OUTLINE OF NEW FEATURES

The following changes have been made for the new Coaster.

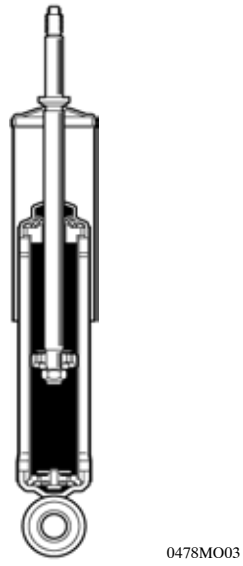
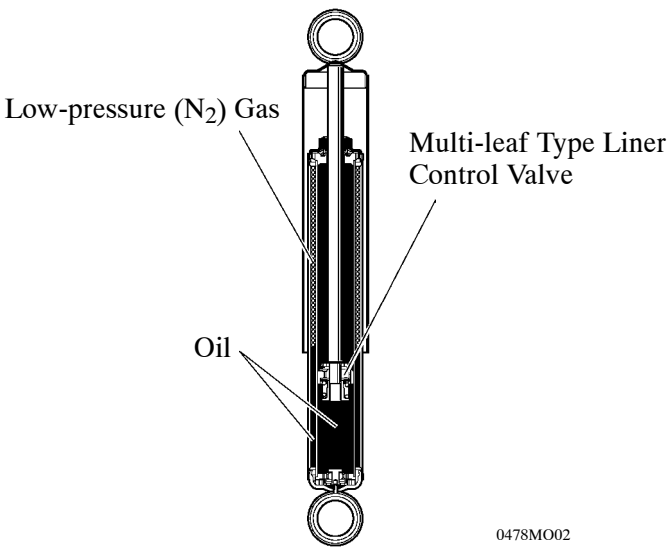
- A low-pressure (N_2) gas type front shock absorber assembly with a multi-leaf type liner control valve has been adopted for the models for Taiwan and Australia, offering both driving stability and riding comfort.

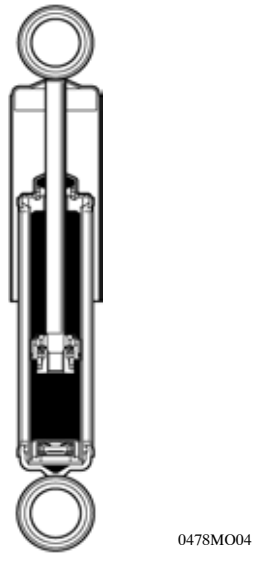
- A low-pressure (N_2) gas type rear shock absorber assembly with a multi-leaf type liner control valve has been adopted for the models for Taiwan and Australia, offering both driving stability and riding comfort.

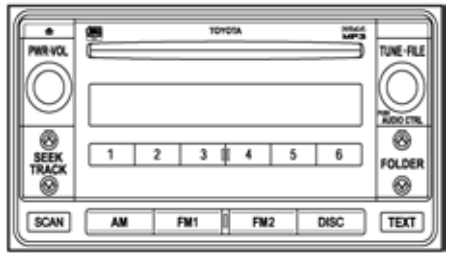
A newly designed audio head unit has been adopted. For details, see page 72.

Antenna Cord Sub-assembly

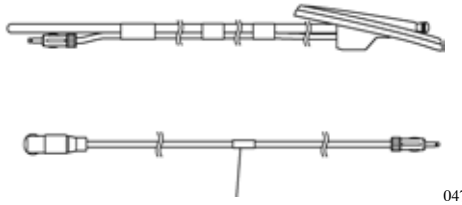
An antenna cord sub-assembly has been provided for separating the antenna cable into two.
